UNITED STATES PATENT AND TRADEMARK OFFICE

APPLICATION NO.	FILING DATE	FIRST NAMED INVENTOR	ATTORNEY DOCKET NO.	CONFIRMATION NO.
10/505,352	08/19/2004	Richard W LeVaughn	2G02.1-080 US	5981

Office Action Summary	Application No. 10/505,352	Applicant(s) LEVAUGHN ET AL.	
	Examiner MICHAEL C. STOUT	Art Unit 3736

DETAILED ACTION

FIG - 694

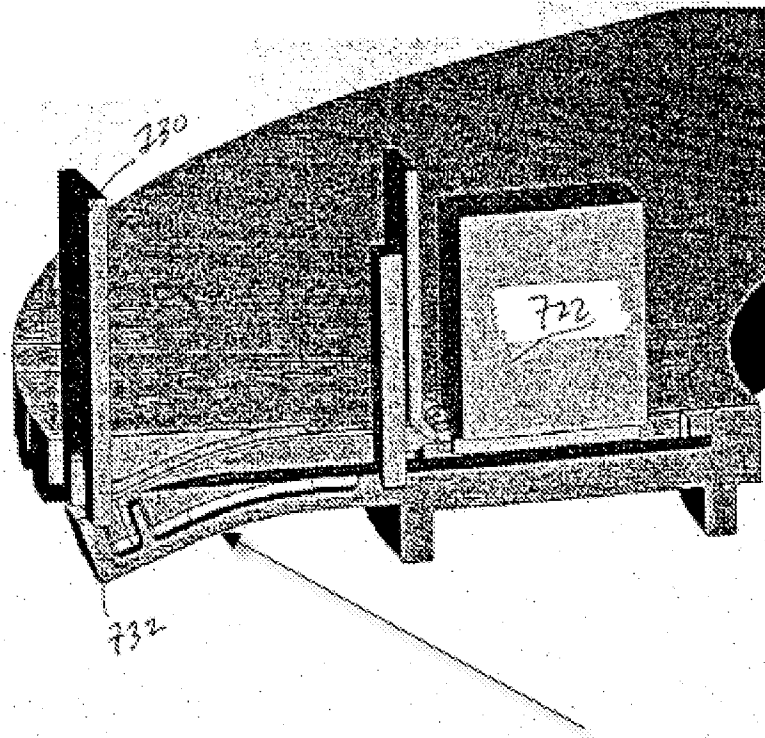
Regarding claim 80, Bobecker teaches the device wherein each of said spring elements comprises a generally U-shaped loop (each of the spring elements comprises a generally u-shaped loop, Figures 69* and see also Figure 65 a).

Spring Element
